U.S. Department
of Transportation
**Federal Highway
Administration**

In Reply Refer To:
HSST-1/CC-126C

- MSKT- SP-MGS (MASH Sequential Kinking Terminal, Standard Posts, Midwest Guardrail System) with Wood Posts.

Wood-Post MSKT System Product Description

Drawing Name: MSKT-MGS-W

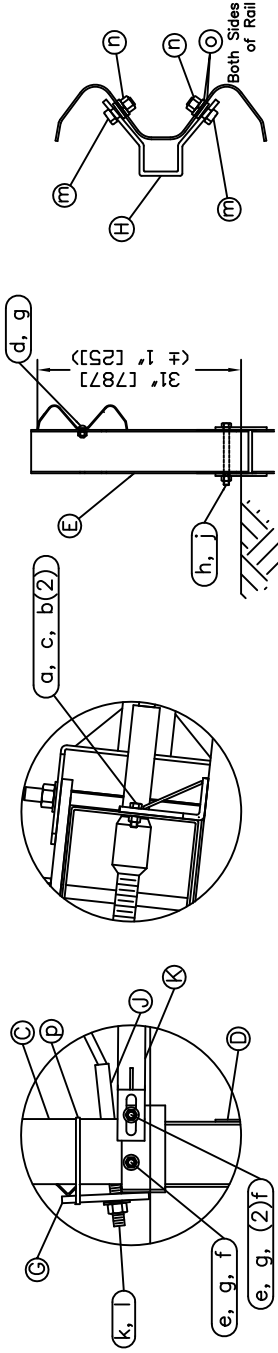
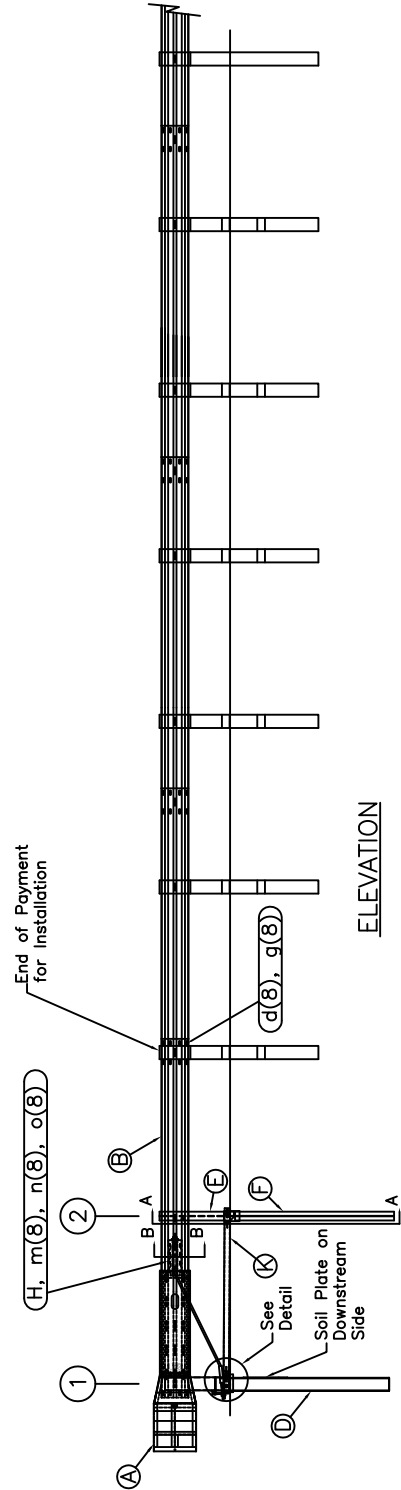
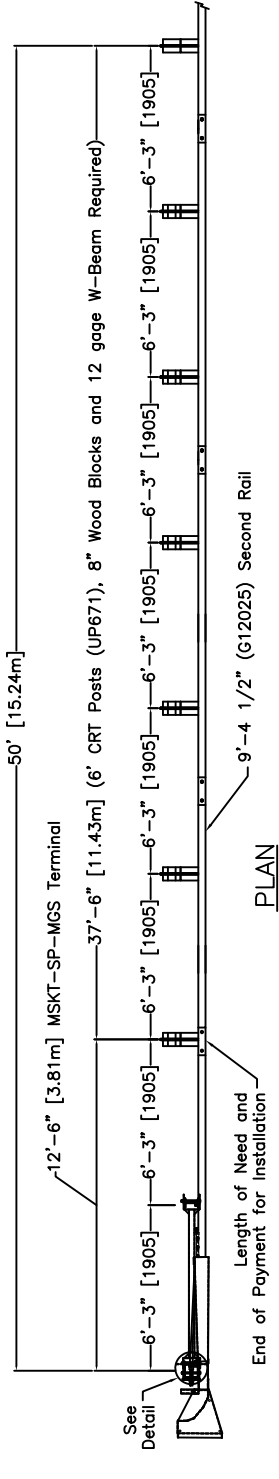
1. Use of CRT wood posts in post locations 3 through 8.

Figure 1 shows a schematic drawing of the wood-post MSKT terminal. The wood-post system uses the same SP anchorage system, i.e., the same steel posts 1 and 2 with a ground strut, as the steel-post system. Posts 3 through 8 are CRT (Controlled Release Terminal) wood posts, and standard wood line posts are used from post 9 and beyond. Other than the posts, the other components of both MSKT systems are the same.

For head-on impacts (Test Designation 30, 31, 32, and 33), both steel-post and wood-post systems should perform the same from the initial point of impact up to post 3 since both systems use the same steel Posts 1 and 2 with a ground strut anchorage system. From Post 3 through Post 8, the wood-post system is, in our opinion, more consistent and predictable than the steel-post system. The wooden CRT posts are designed to break away at a given force level when impacted in a longitudinal direction. In comparison, the standard steel line posts are simply pushed down when impacted in a longitudinal direction to allow for vehicle to pass over the bent posts. Thus, there is more debris on the ground in the path of the vehicle for the steel-post system, which could potentially cause the vehicle to roll and yaw. Thus, we believe that the wood-post system would perform in a more consistent and predictable manner than the steel-post system for head-on and shallow angle impacts.

FHWA concurs with the recommendation of the accredited crash testing laboratory as stated within the attached form.
